*Bridge Preliminary Design Report
Addendum*

**Ramp C over Norfolk Southern Tracks
SCI-823-1603**

**SCI-823-10.13
PID No. 79977**

to:	James A. Brushart, District 9 Deputy Director	date:	Apr. 15, 2008
from:	Timothy J. Keller, Administrator, Office of Structural Engineering by: Ananda Dharma, P.E.		
subject:	SCI-823-10.17; PID 79977; Bridge No. SCI-823-1603; Ramp C over Norfolk Southern Railroad; Preliminary Design Review

Site Plan - Sheet 1 of 3

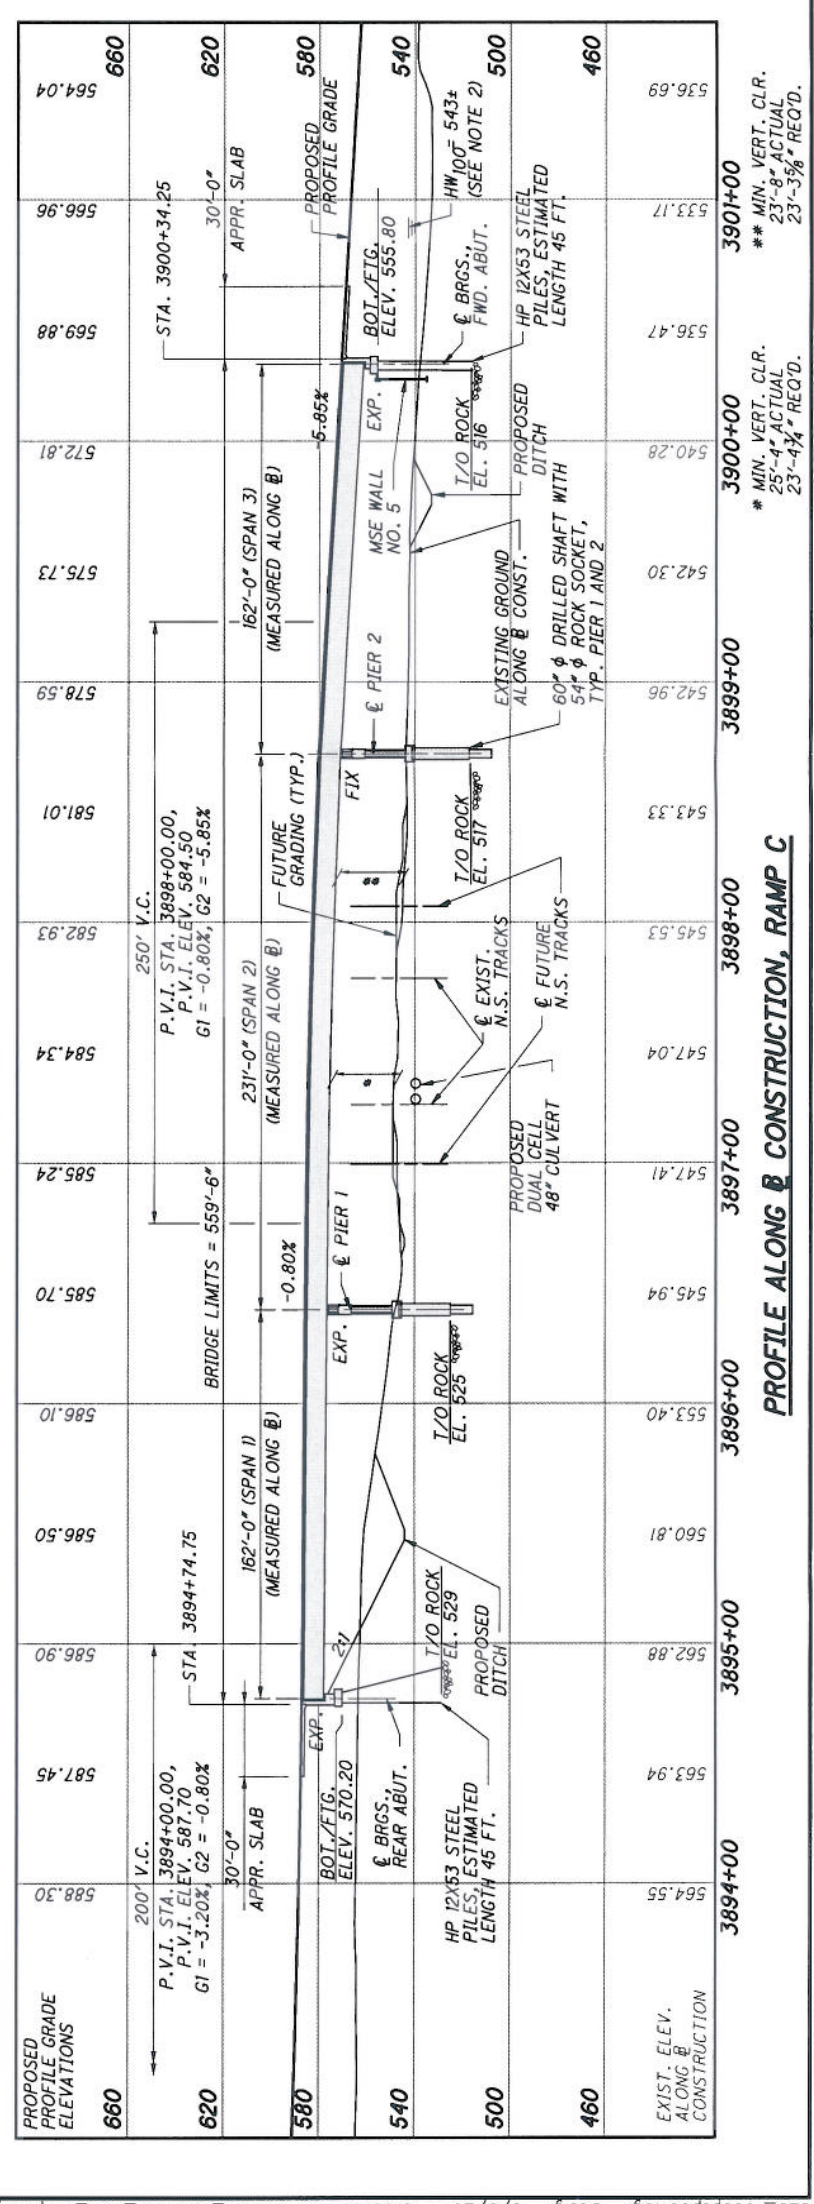
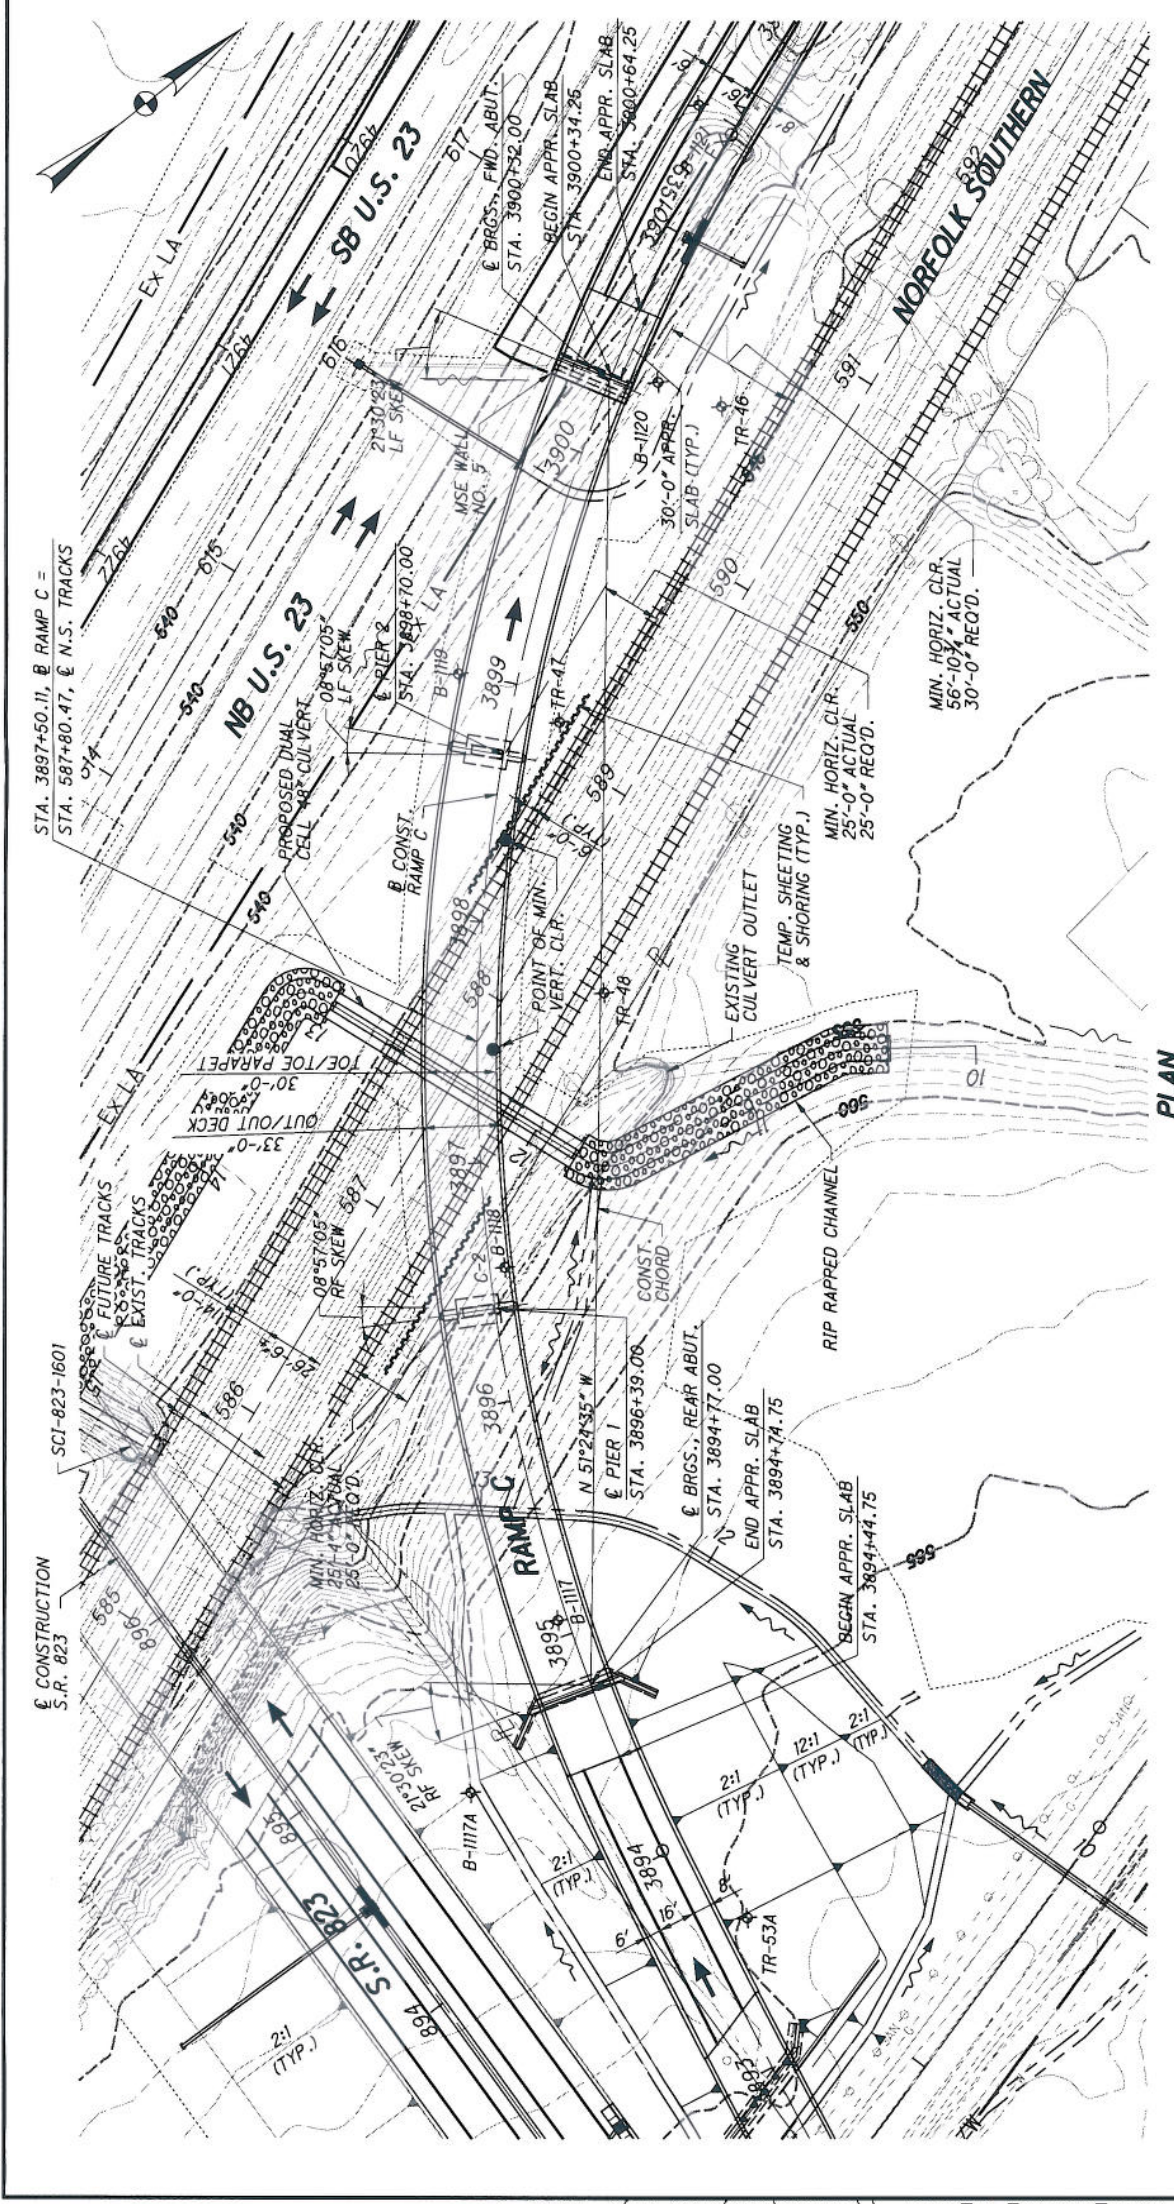
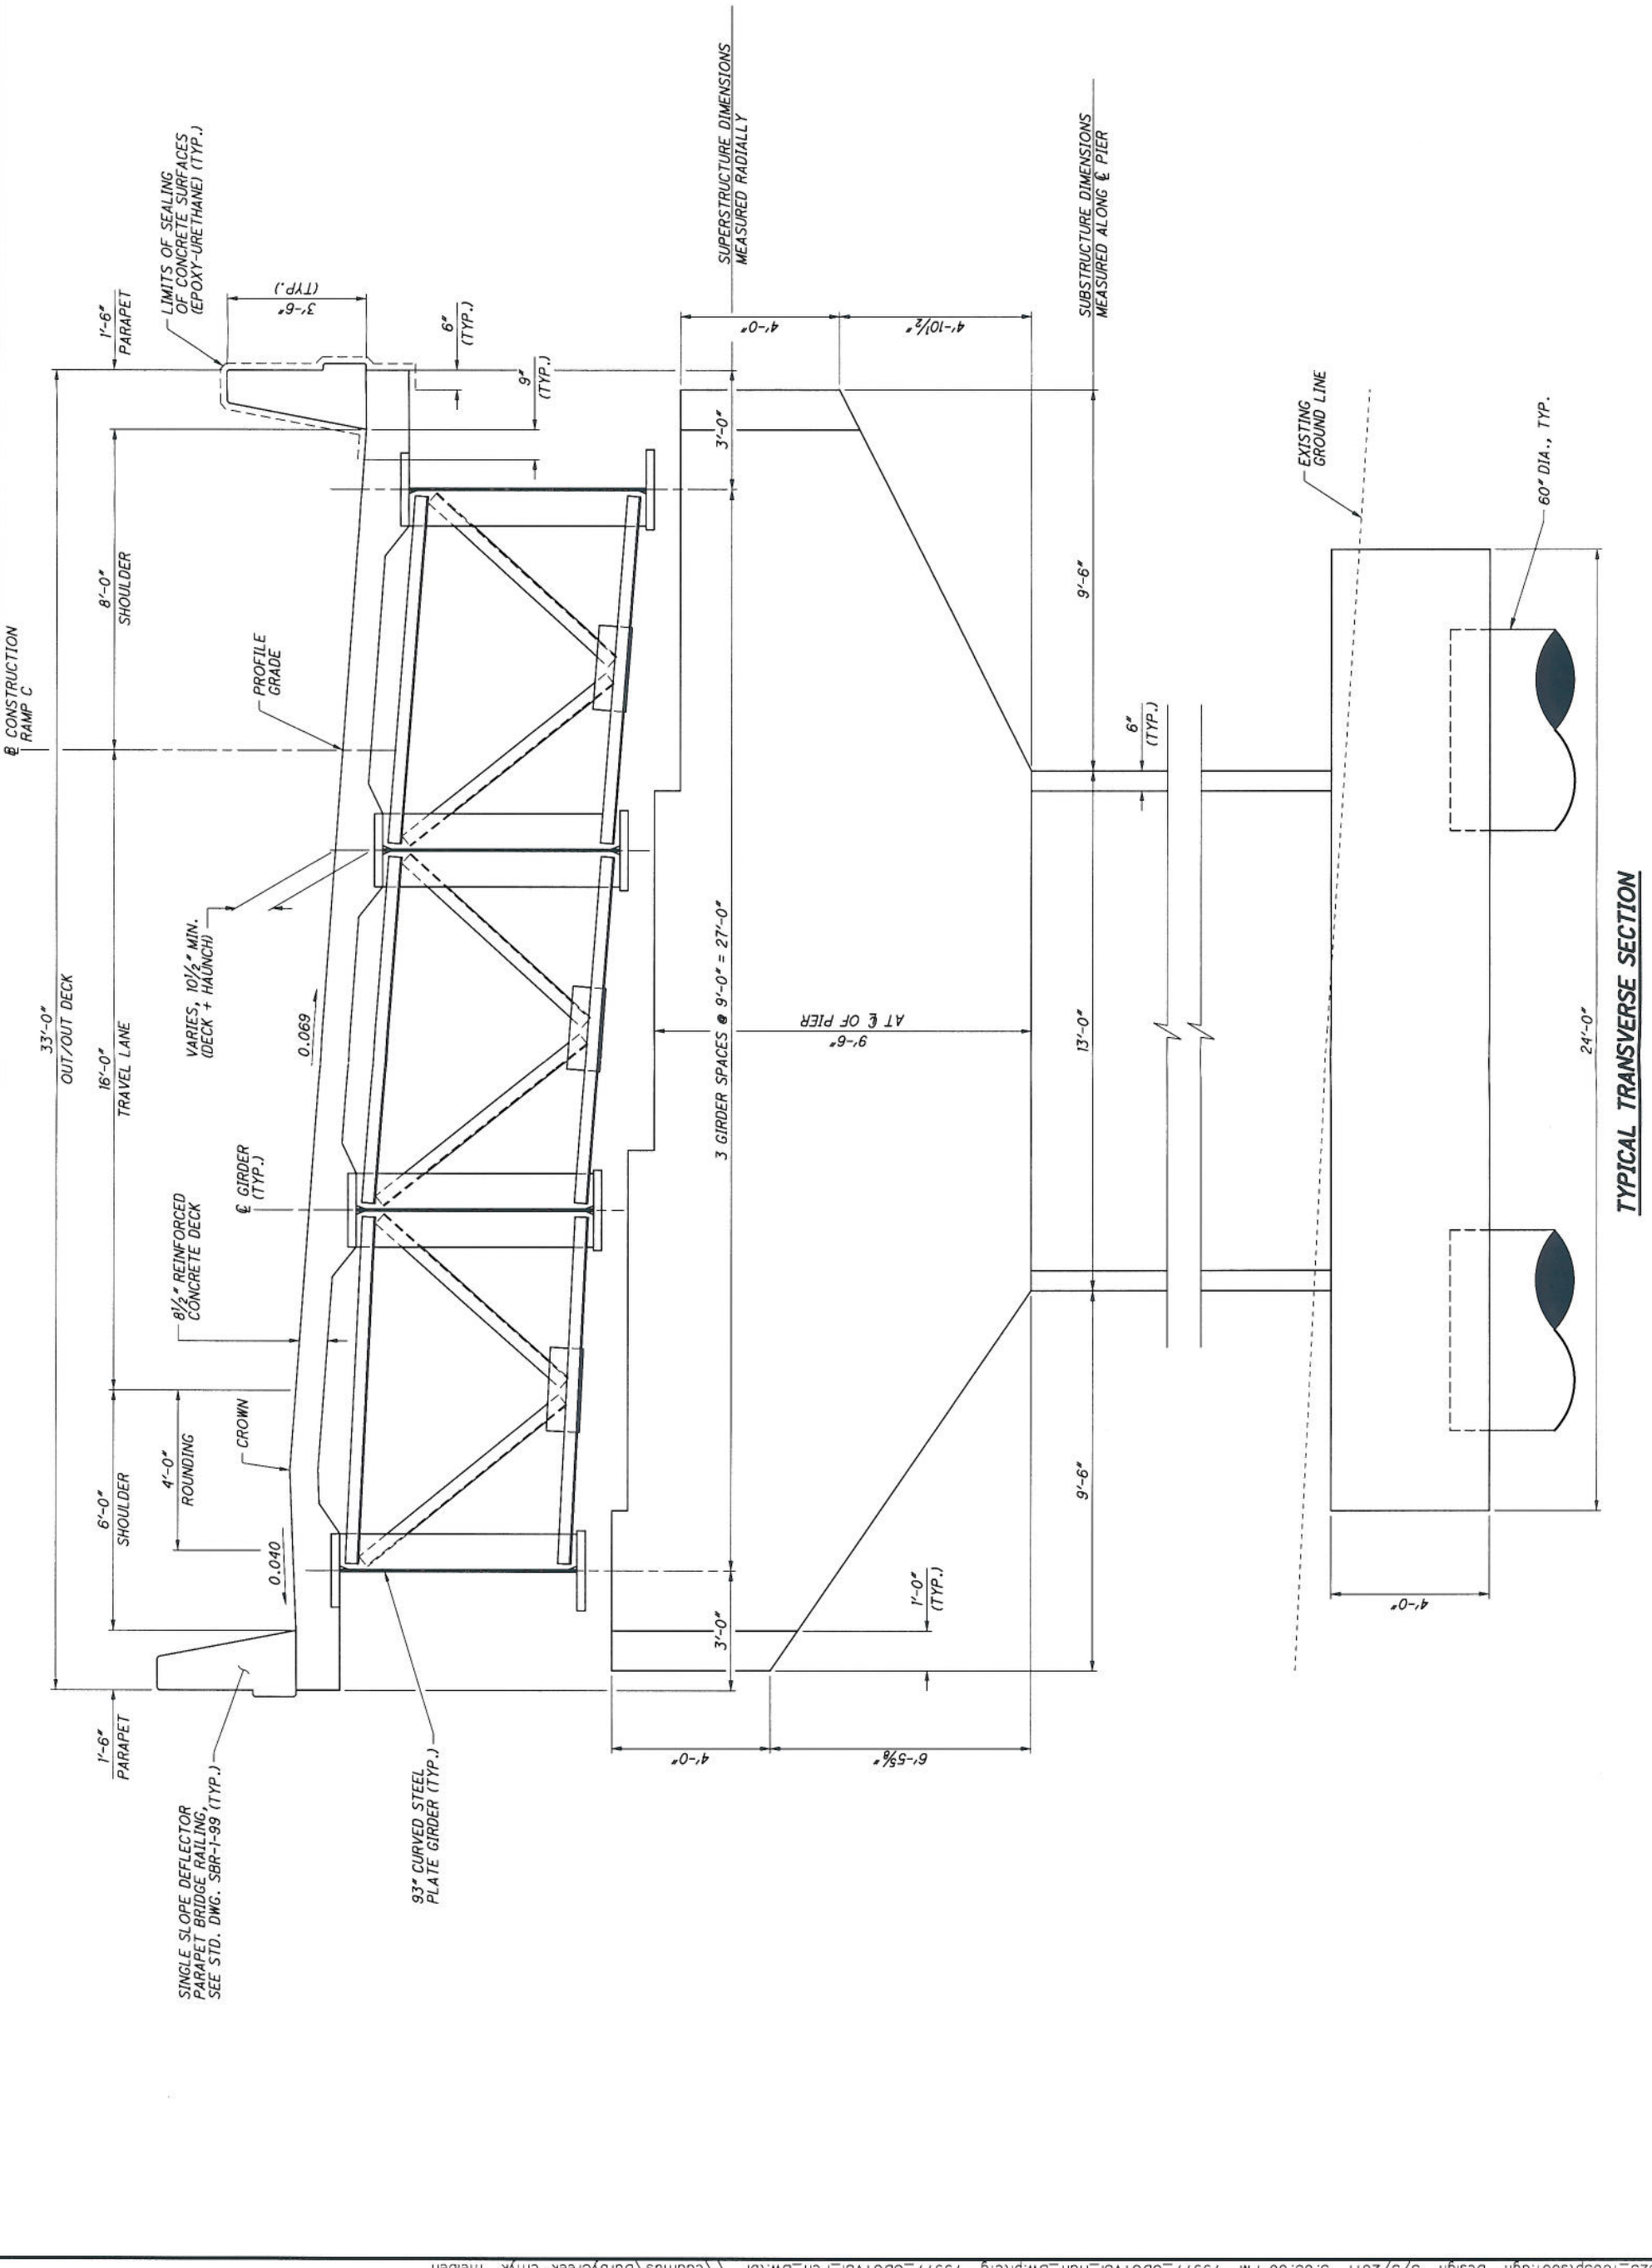
6. In the Plan view, please avoid texts on top of other texts or on top of the lines by moving the texts or masking the lines because they are difficult to read.

7. The actual unfactored design loads of 75 tons and 95 tons correspond to HP10x42 and HP12x53, respectively. Please refer to BDM 202.2.3.2.a which was updated in the 2007 Fourth Quarter Revisions. The increase in the maximum allowable design loads for H-piles driven to refusal is to take advantage of the Grade 50 steel that is now used for steel piles.

8. Anchor dowels for the proposed fixed bearings at Pier 2 have to be designed to resist all forces, such as, centrifugal force, wind load force and also gravity force because there is a tendency for the entire steel superstructure to move downhill towards the forward abutment. Please incorporate this comment to other structures having similar configuration as this structure.

9. Please provide the location and description of benchmarks in the next submittal. (BDM 202.2.1)
10. In the Proposed Structure data block, Length of Span on curved alignments should be measured along a reference line which is a chord drawn from centerline of abutment bearings at the centerline of survey or baseline of construction. (BDM 202.2.1)

5	In the Preliminary Design Report dated November 2007, page 5 discussed "H" steel piles vs. drilled shafts for pier foundation. The Design Consultant needs to prepare cost comparison and/or justification for the proposed pier foundation in order to determine the most economical pier foundation.	Acknowledged. This study is underway and will be submitted to ODOT as an addendum to the Bridge Preliminary Design Report.
6	In the Plan view, please avoid texts on top of other texts or on top of the lines by moving the texts or masking the lines because they are difficult to read.	Acknowledged.

7	The actual unfactored design loads of 75 tons and 95 tons correspond to HP10x42 and HP12x53, respectively. Please refer to BDM 202.2.3.2.a which was updated in the 2007 Fourth Quarter Revisions. The increase in the maximum allowable design loads for H-piles driven to refusal is to take advantage of the Grade 50 steel that is now used for steel piles.	Acknowledged.
8	Anchor dowels for the proposed fixed bearings at Pier 2 have to be designed to resist all forces, such as, centrifugal force, wind load force and also gravity force because there is a tendency for the entire steel superstructure to move downhill towards the forward abutment. Please incorporate this comment to other structures having similar configuration as this structure.	Acknowledged.
9	Please provide the location and description of benchmarks in the next submittal. (BDM 202.2.1)	Benchmark information will be provided as soon as that information is available.

10	In the Proposed Structure data block, Length of Span on curved alignments should be measured along a reference line which is a chord drawn from centerline of abutment bearings at the centerline of survey or baseline of construction. (BDM 202.2.1)	Acknowledged. Span lengths will be measured along the construction chord and Proposed Structure data block will be updated accordingly.
